UNITED STATES PATENT AND TRADEMARK OFFICE

Office Action Summary	Application No.	Applicant(s)
	10/632,545	BRLETICH ET AL.
	Examiner Ernesto Garcia	Art Unit 3679

DETAILED ACTION

Antonucci et al., 6,119,306

FIG. 35

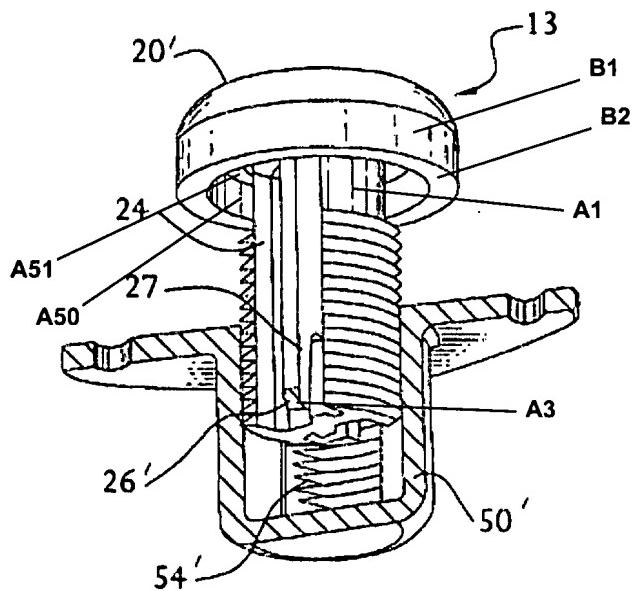
Regarding claim 1, Antonucci et al. disclose, in Fig. 35, a device comprising a fastener plug 13 including a plug portion 20' and a fastener portion 24. The plug portion 20' defines an end cap 20' and at least one disc 28 spaced apart from the end cap 20'. The fastener portion 24 defines a flexible extension member 27 extending outwardly from the end cap 20' and across the at least one disc 28. The extension member 27

includes a projecting member **26'**. The end cap **20'** includes at least one retaining wall **A50** (see marked-up attachment) extending outwardly from an inner surface **A51** of the end cap **20'**.

Given the structure of Antonucci et al. above, the disc is sized and shaped to mate with and can seal an open end of a bar. The flexible extension member is able to flex as the member is installed in the open end of the bar and snap back to an original position when the projection member engages an aperture in a sidewall of the bar. Further, the disc defines a diameter slightly larger than a diameter of the open end of the bar, and the projection member can be adapted for operatively engaging the aperture in the sidewall of the bar. Further, the retaining wall can seat against and within the open end of the bar.

Regarding claim 2, the end cap **20'** defines a peripheral edge **B1** (see marked-up attachment) and a flat surface edge **B2** along the peripheral edge **B1**. Note, the claims are written with a broad breadth that Antonucci et al. reads on this claim. Applicants should consider rephrasing that the peripheral edge has a truncated edge or truncated surface.

Regarding claim 3, a rib **A1** connects the disc **28** to the end cap **20'**.

Regarding claim 4, the disc **28** is a plurality of discs **28** spaced apart from the end cap **20'**.

Regarding claim 5, the extension member **27** extends upwardly from the end cap **20'**.

Regarding claim 6, the extension member **27** extends across the discs **28**.

Regarding claim 7, the discs **28** define a flat surface edge **A2**.

Regarding claim 8, the projection member **26'** defines an inclined surface **A3**.
